U.S. EPR Pressure-Temperature Limits Methodology for RCS Heatup and Cooldown

ANP-10283NP-A
Revision 2

SUBJECT: SAFETY EVALUATION REPORT FOR THE AREVA U.S. EPR PRESSURE AND TEMPERATURE LIMITS REPORT

SAFETY EVALUATION BY THE OFFICE OF NEW REACTORS
REVIEW OF THE UNITED STATES EVOLUTIONARY POWER REACTOR (U.S. EPR)
GENERIC PRESSURE-TEMPERATURE LIMITS REPORT
AREVA NP Inc.

Figure 6-1 U.S. EPR RCS P-T Limits – Normal Heatup with ISLH and Criticality Limit Curves Applicable to 60 EFPY

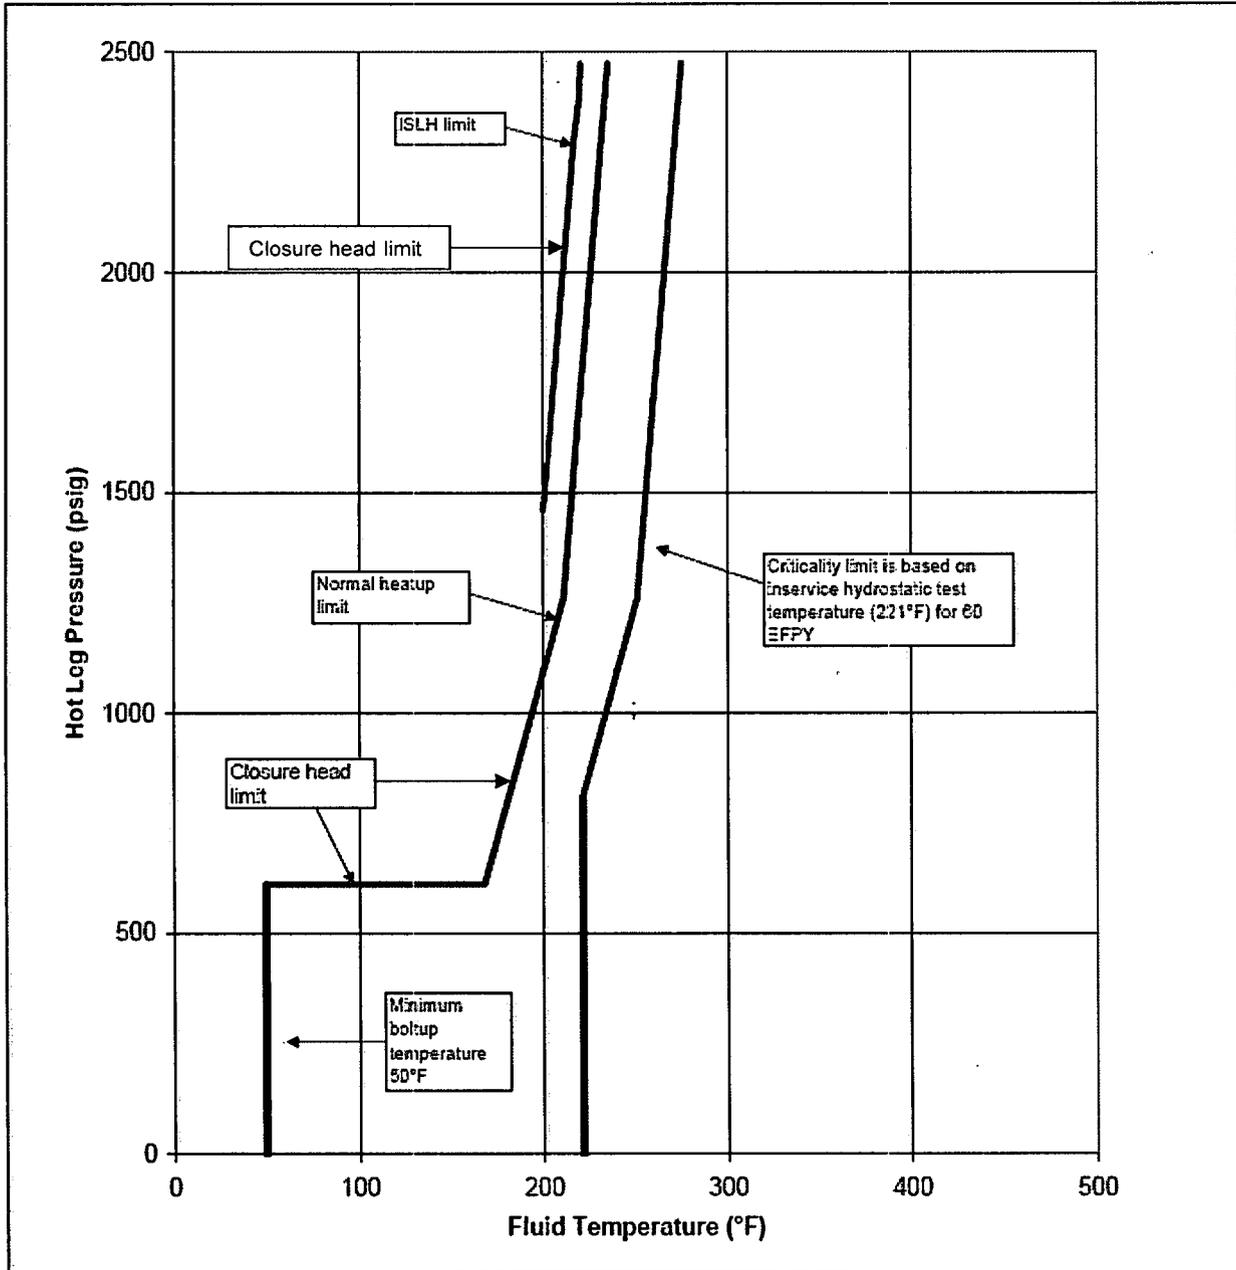
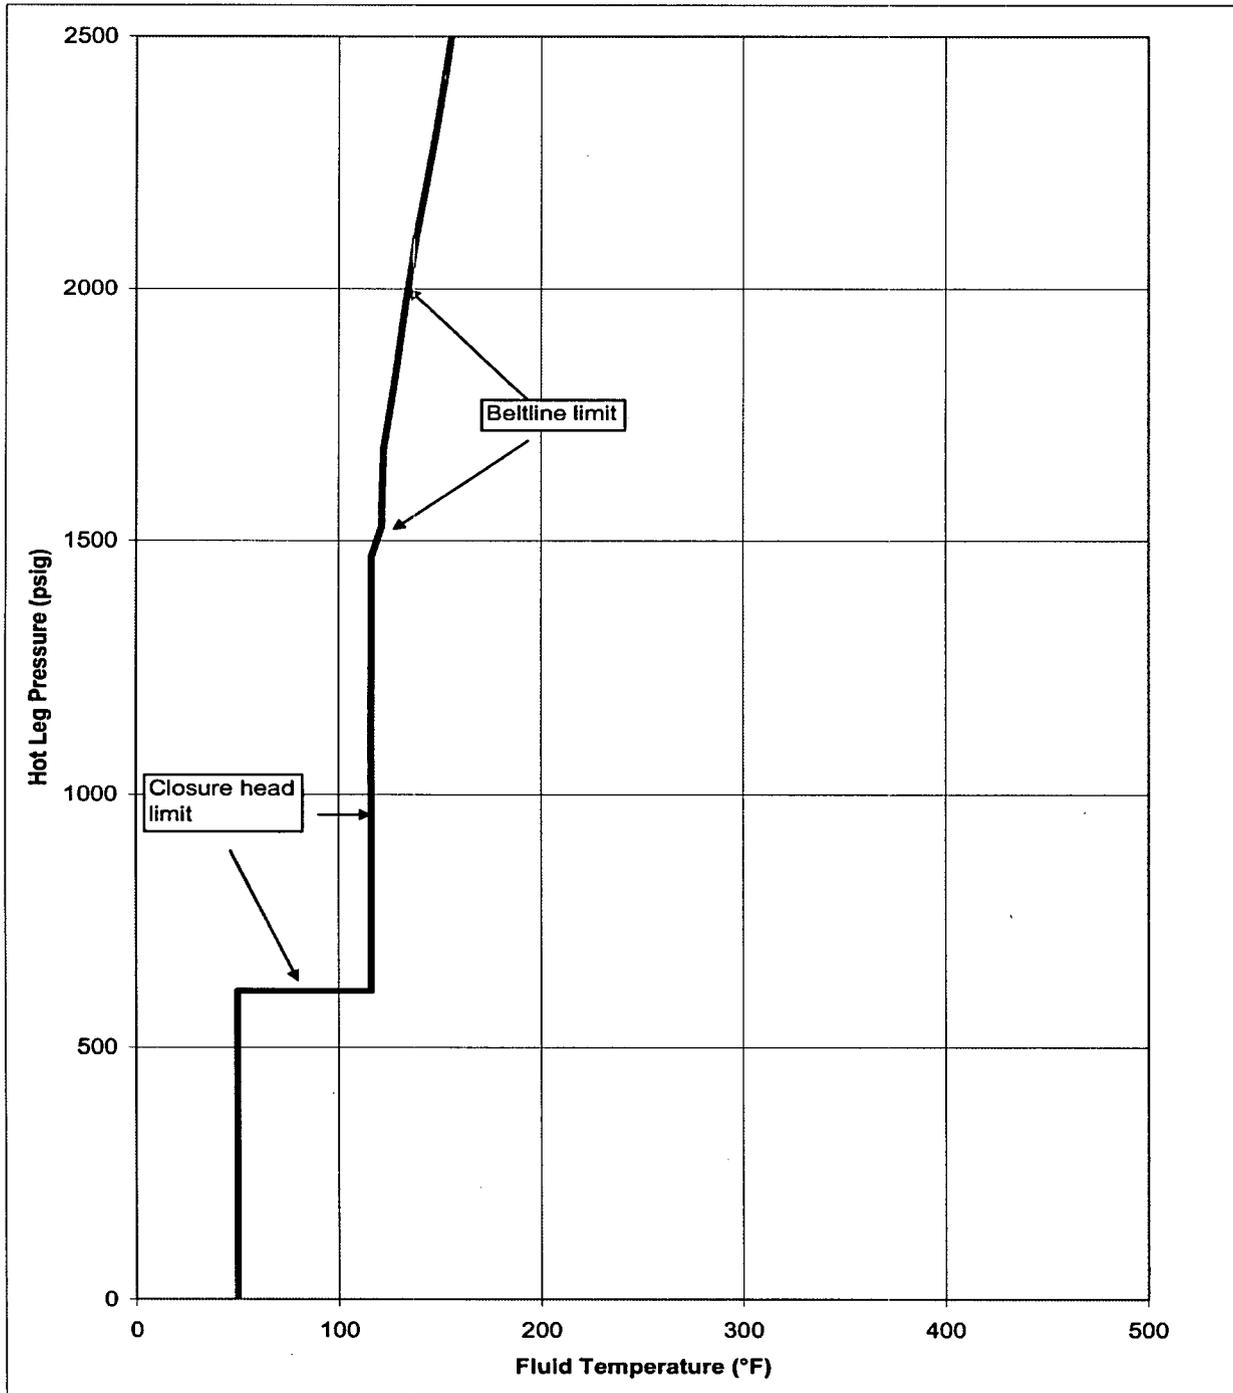
was unclear to the NRC staff how these materials would be used to develop a P-T limit curve that represents the EPR reactor vessel. Therefore, the NRC staff issued RAI 05.03.02-11 requesting the applicant to explain specifically how these materials would be used to develop the bounding P-T limit curves. The applicant responded that for normal heatup and inservice leak and hydrostatic heatup (ISLH) conditions, the pressure-temperature limits for the entire temperature range are controlled by the reactor vessel closure head as shown in Figure 6-1. The applicant also stated that for normal cooldown, different components are controlling during different temperature ranges. In the low-temperature range (50°F to 116°F) the closure head is the controlling component. From 116°F to 138°F, the upper/lower core shell is the controlling component. At temperatures above 138°F, the controlling component is weld #2.

The corresponding 60 EFPY ART values of the limiting materials at the 1/4T and 3/4T locations are shown in Table 6-2 of the U.S. EPR PTLR. The staff confirmed the applicant's controlling materials for heatup (closure head) and cooldown (closure head, upper/lower core shell, and weld #2) conditions and performed an independent calculation of the ART values for the beltline materials using the RG 1.99, Revision 2 methodology. On the basis of this evaluation, the NRC staff found that the applicant's response to RAI 05.03.02-11 was acceptable and confirmed that the U.S. EPR PTLR has been updated with the information provided. Therefore, RAI 05.03.02-10 and RAI 05.03.02-11 are closed. The staff also verified that the RT_{PTS} calculations, shown in Table 6-5 of the U.S. EPR PTLR, complied with the requirements of 10 CFR 50.61. The limiting RT_{PTS} value of 141.1 °F at 60 EFPY corresponds to weld #2.

The NRC staff performed independent analyses for the derivation of P-T limits curves and obtained almost identical solutions as those provided in the U.S. EPR PTLR for heat-up and cool-down operations, core critical operations, and hydrostatic and pressure testing; thus, providing verification of the P-T limits for the U.S. EPR standard plant design. Based on this independent verification, the NRC staff concluded that the applicant's proposed P-T limits were developed in accordance with ASME Code, Section XI, Appendix G and; therefore, satisfy the requirements of 10 CFR Part 50, Appendix G. Therefore, the applicant's proposed P-T limit curves are acceptable for operation of the EPR RV. On this basis, the NRC staff concluded that the provisions of PTLR Criterion 5 are satisfied.

6.0	Added footnotes to Figures 6–1 and 6–2 to clarify the use of both materials to develop the bounding P-T limit curves provided in the U.S. EPR PTLR.
